Planning Board AGENDA

Re: Revised Site Plan Review comments- 404 Silver Street Agawam, MA 01001;

**Re: Battery Energy Storage System (BESS), 404 Silver Street, Agawam MA
Response to Comments – Site Plan Review Application**

Proposed Hotel

C-4.0

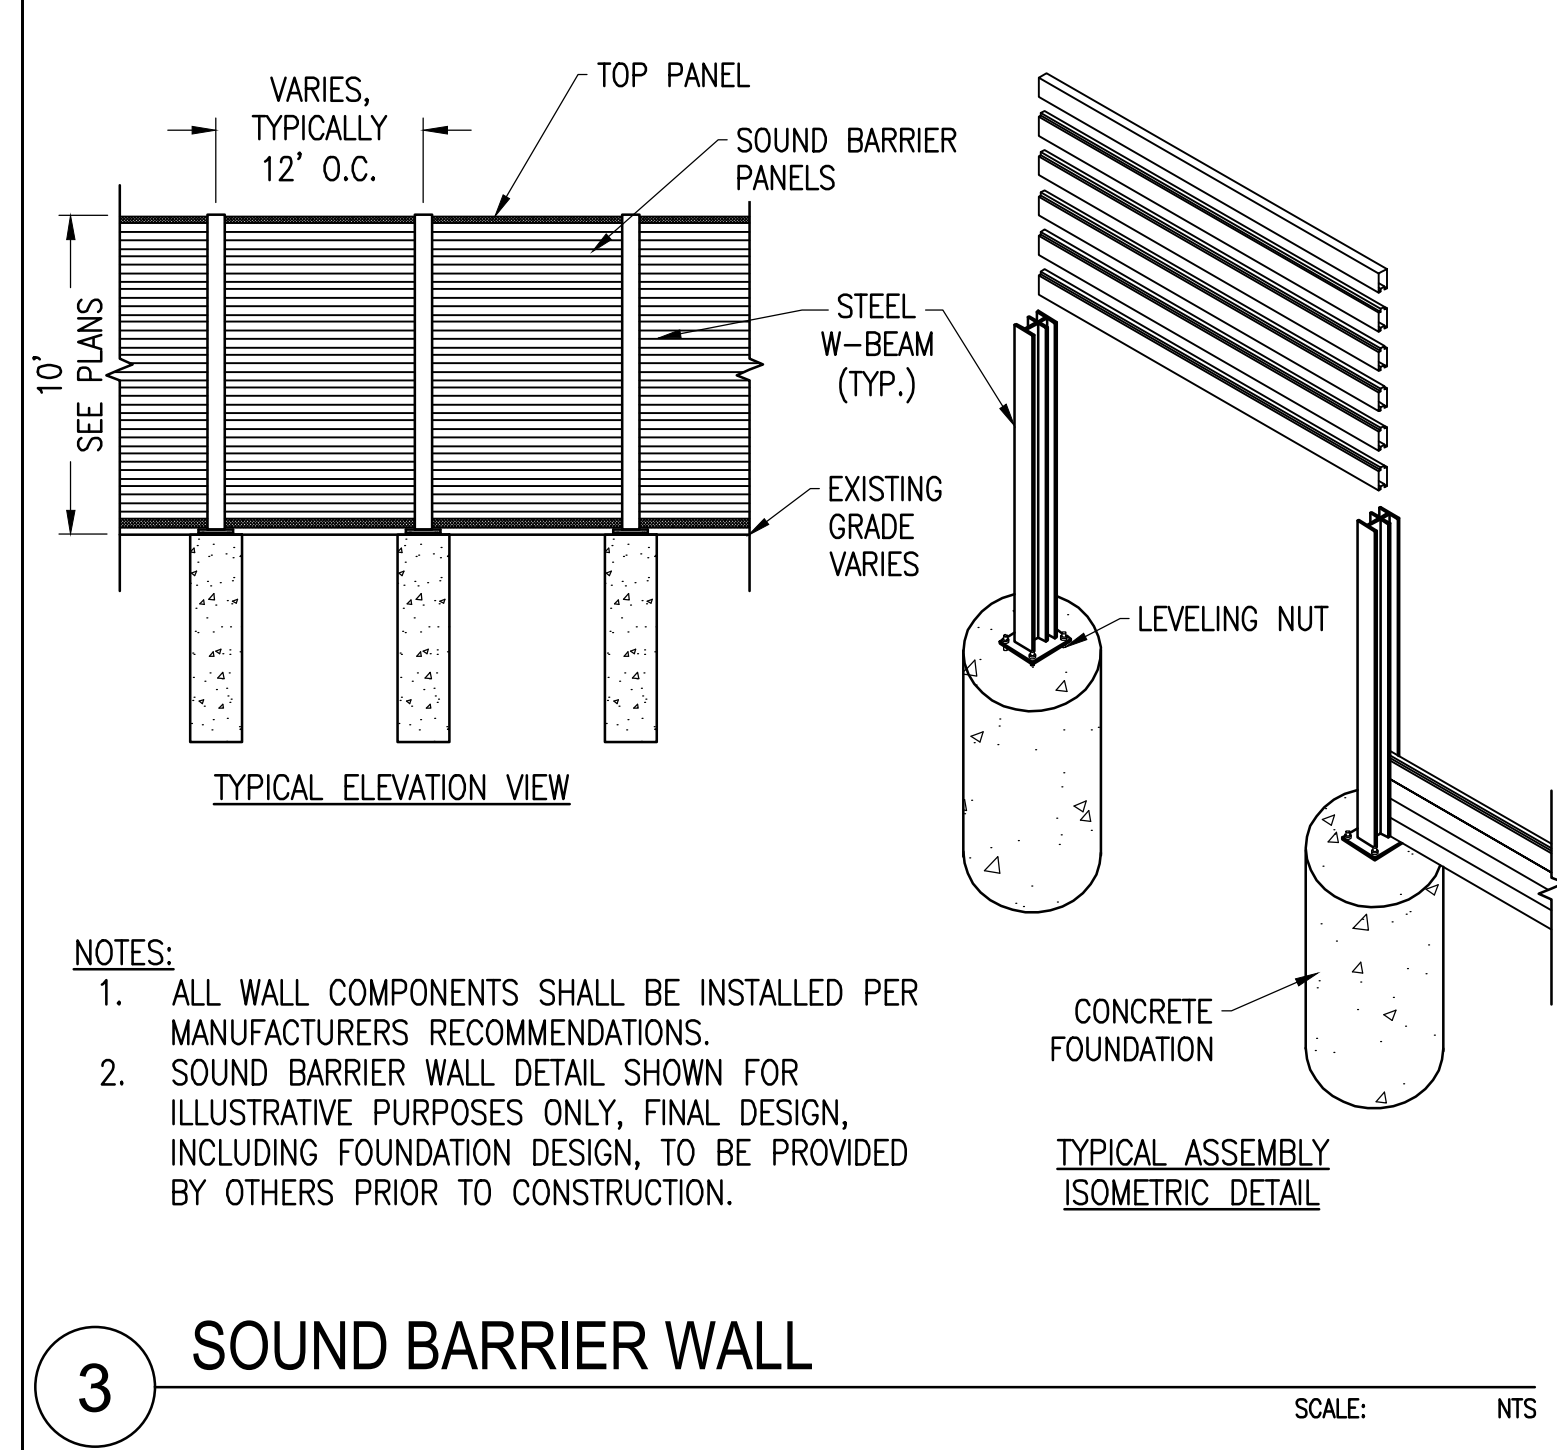
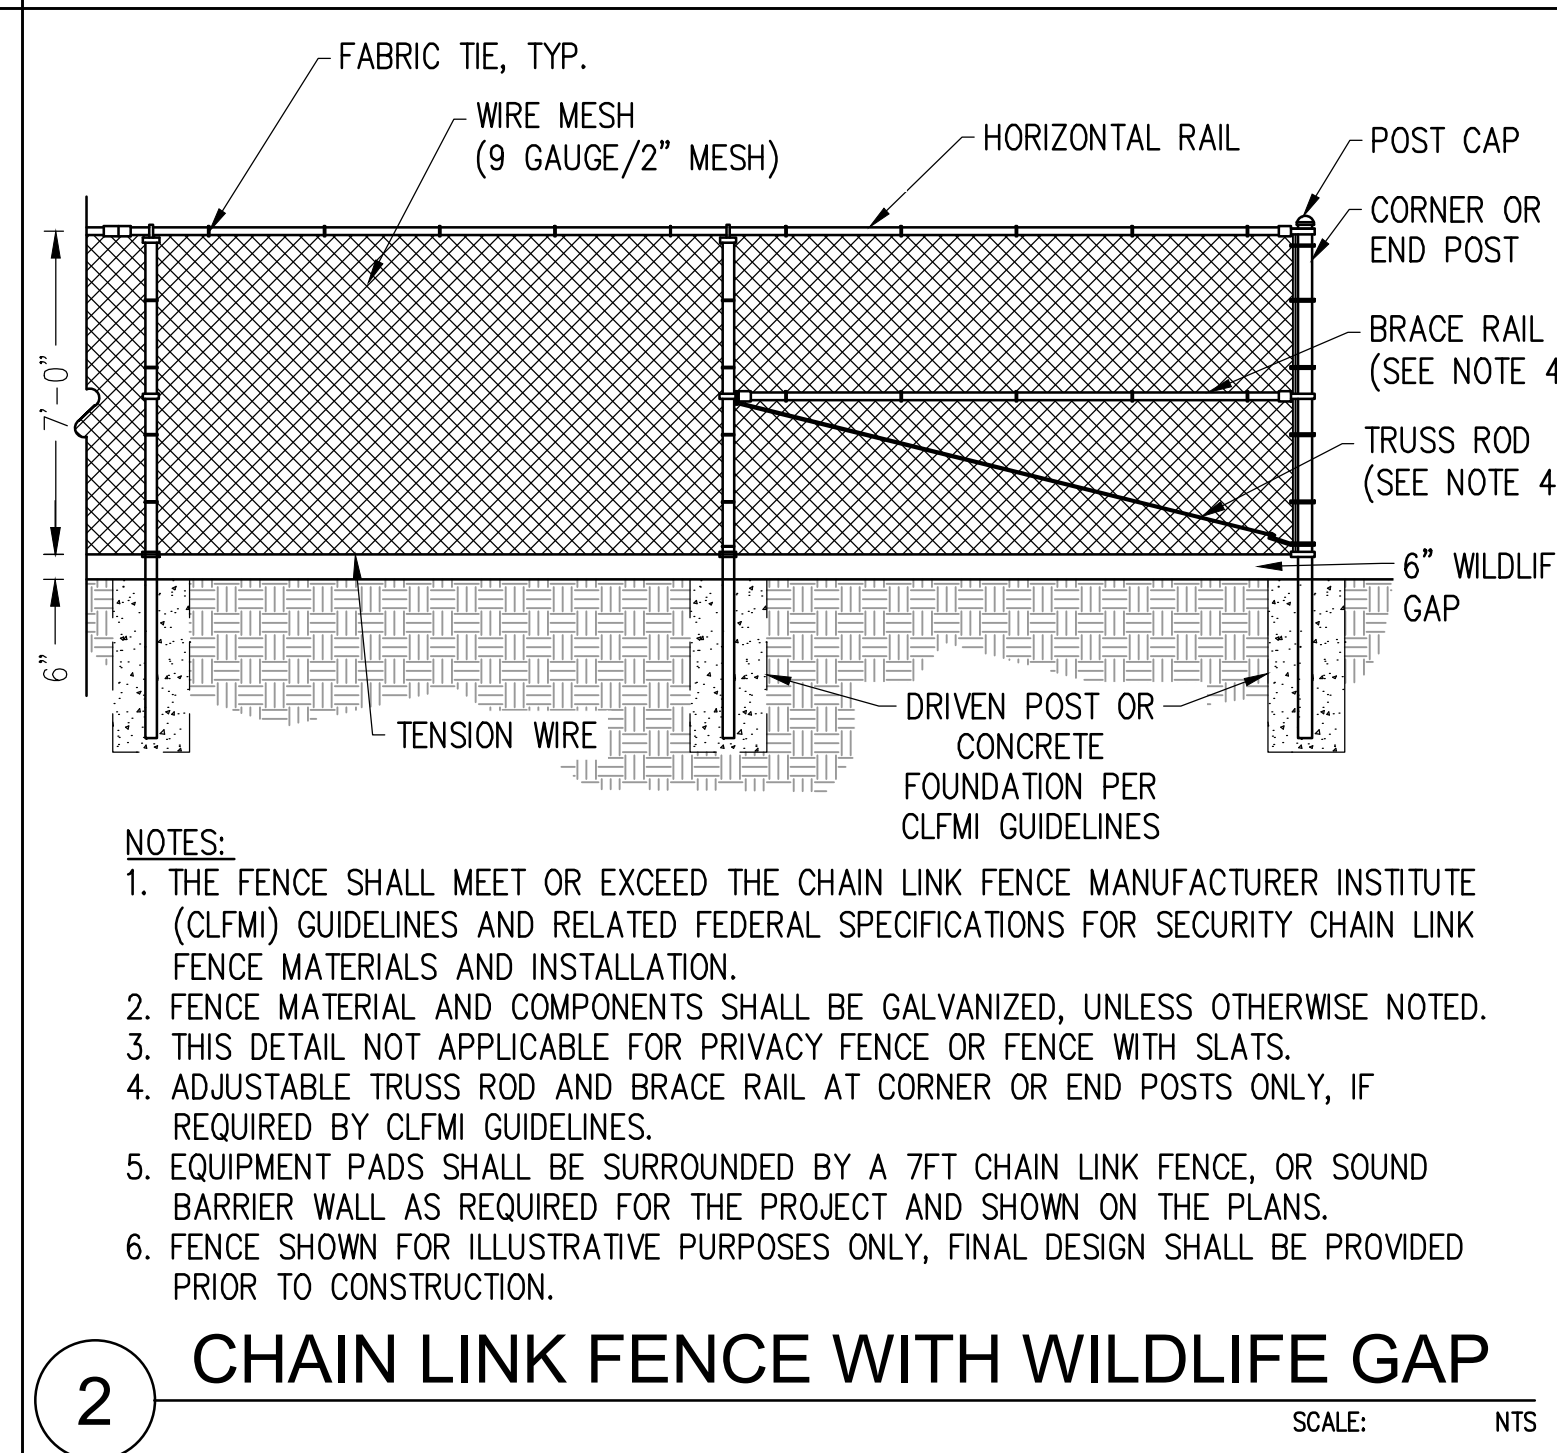
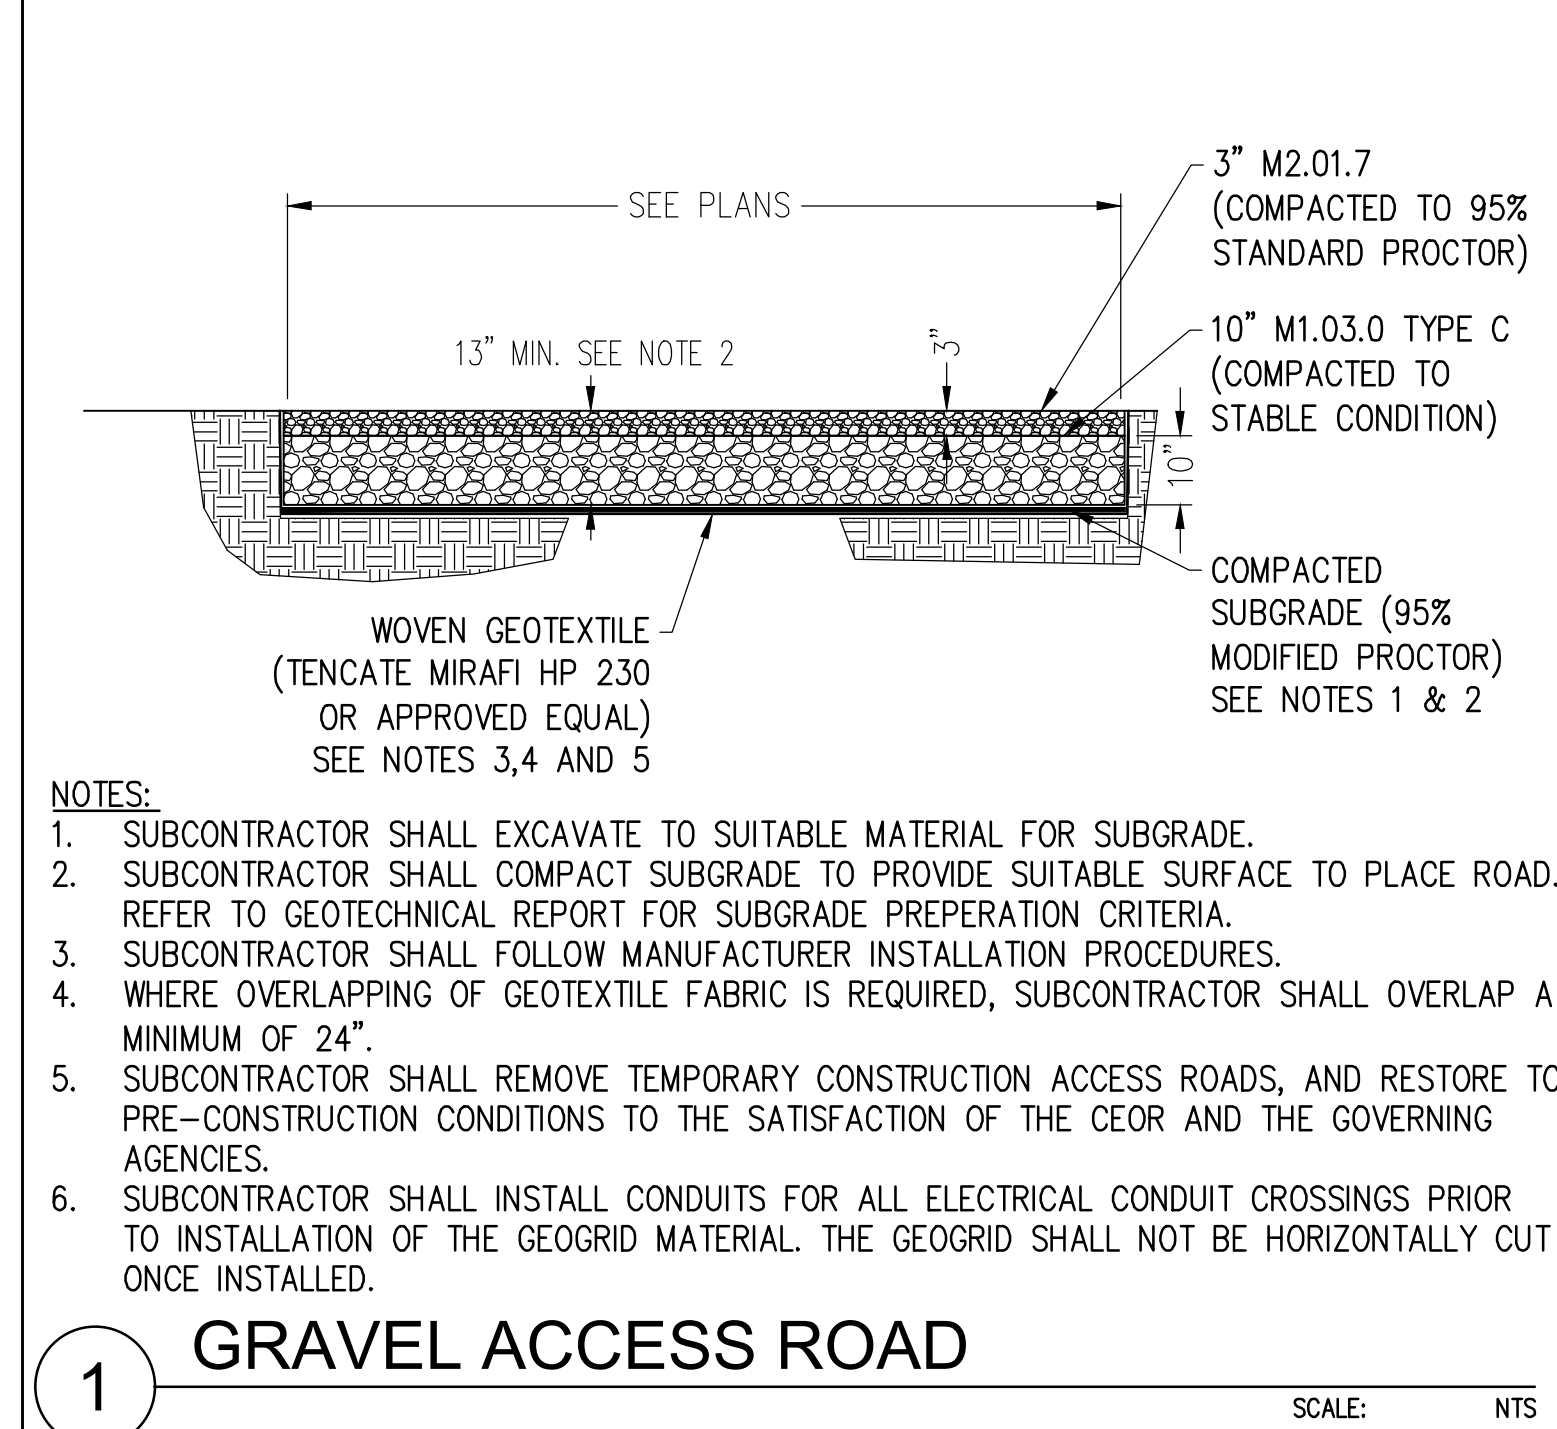
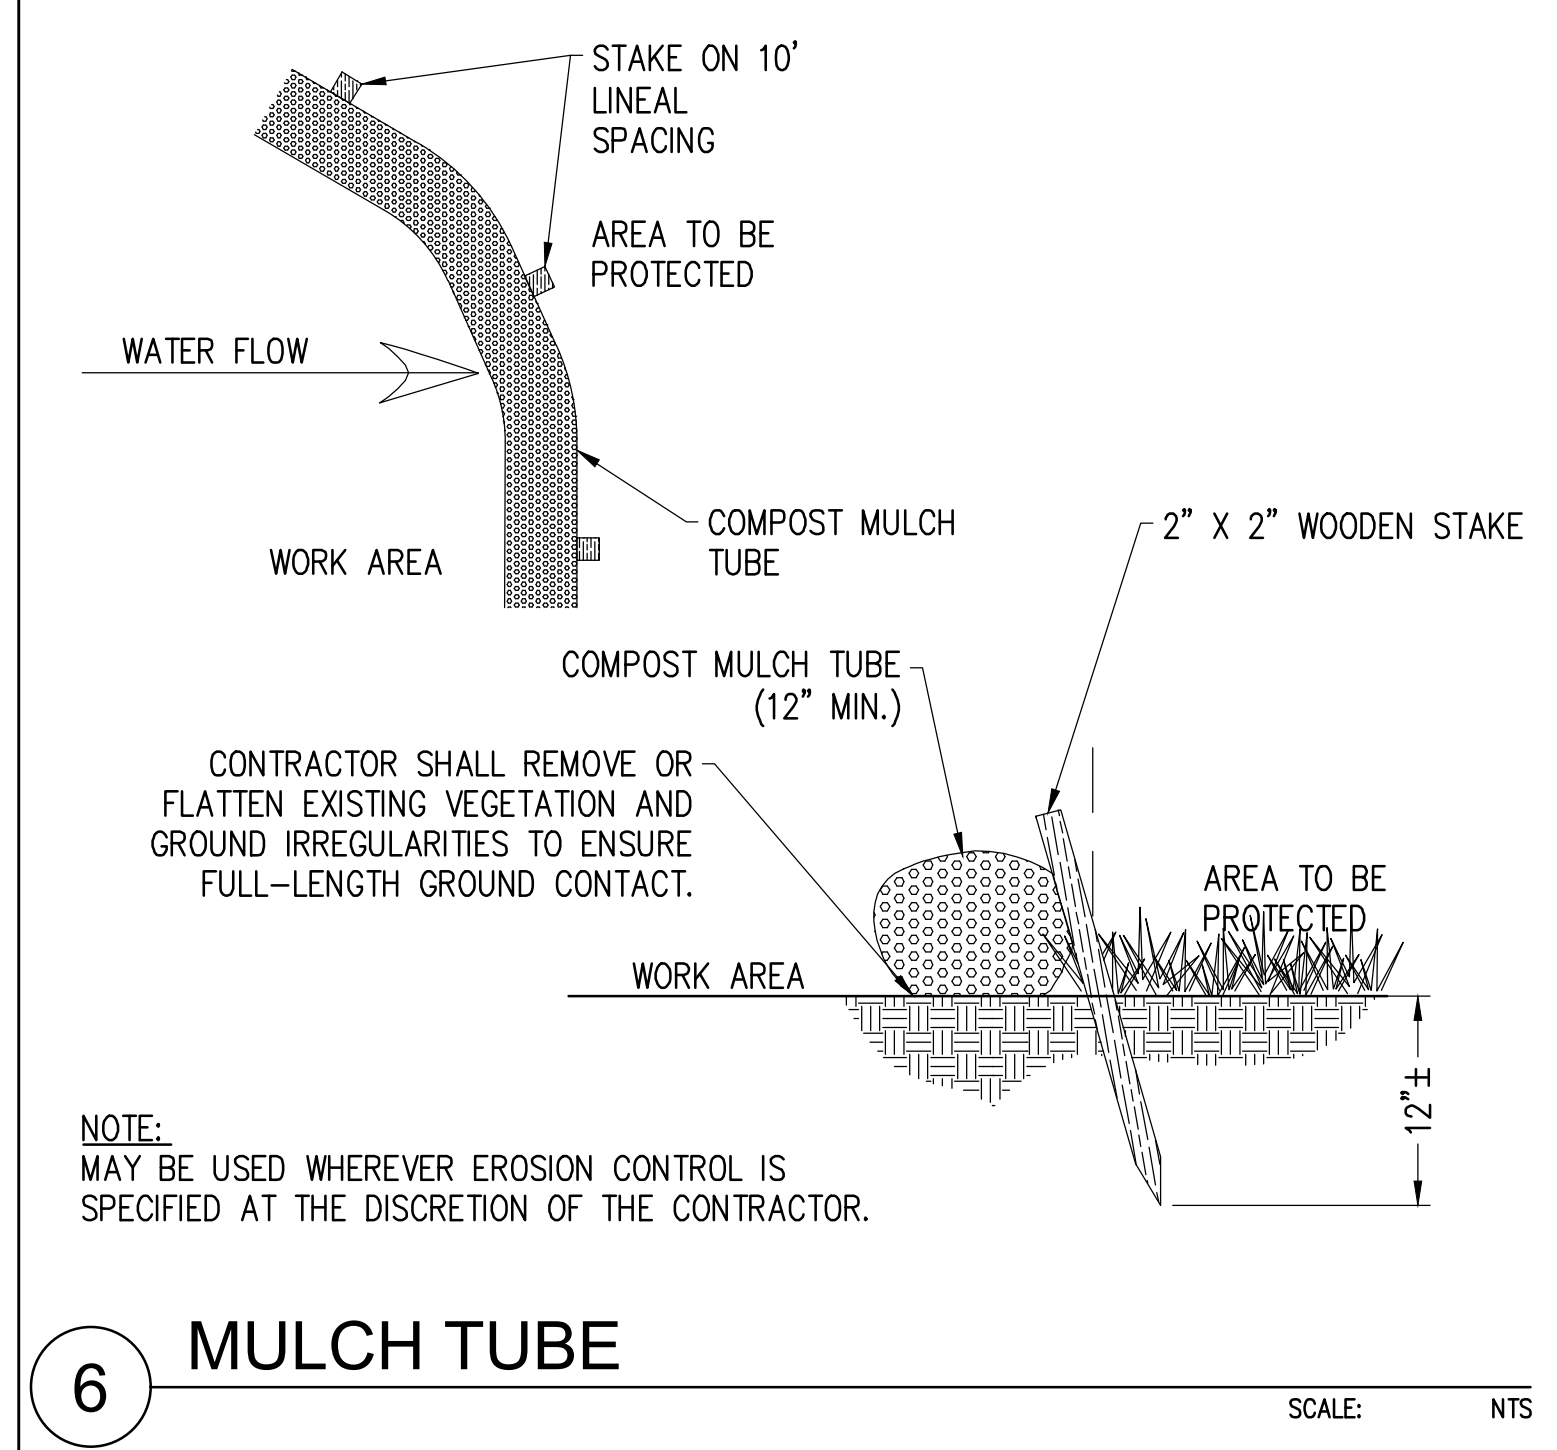
- 2. The plan calls for a silt fence to be installed on the east side of the driveway only at the very end of said driveway. Please extend the silt fence along the limit of work for the entire east side of the driveway.**

- 4. Sheet C-4.0 of the plans has a leader pointing to a riprap swale but it is unclear how that swale is graded and the extents of its location.**

The Grading and Erosion Control Plan (Sheet C-4.0), included in Attachment A, illustrates the revised silt fence location, extending along the limit of work for the entire east side of the driveway.

The riprap swale has been removed from the project plans and replaced with a stone infiltration trench as shown on the Grading and Erosion Control Plan (Sheet C-4.0) included in Attachment A.
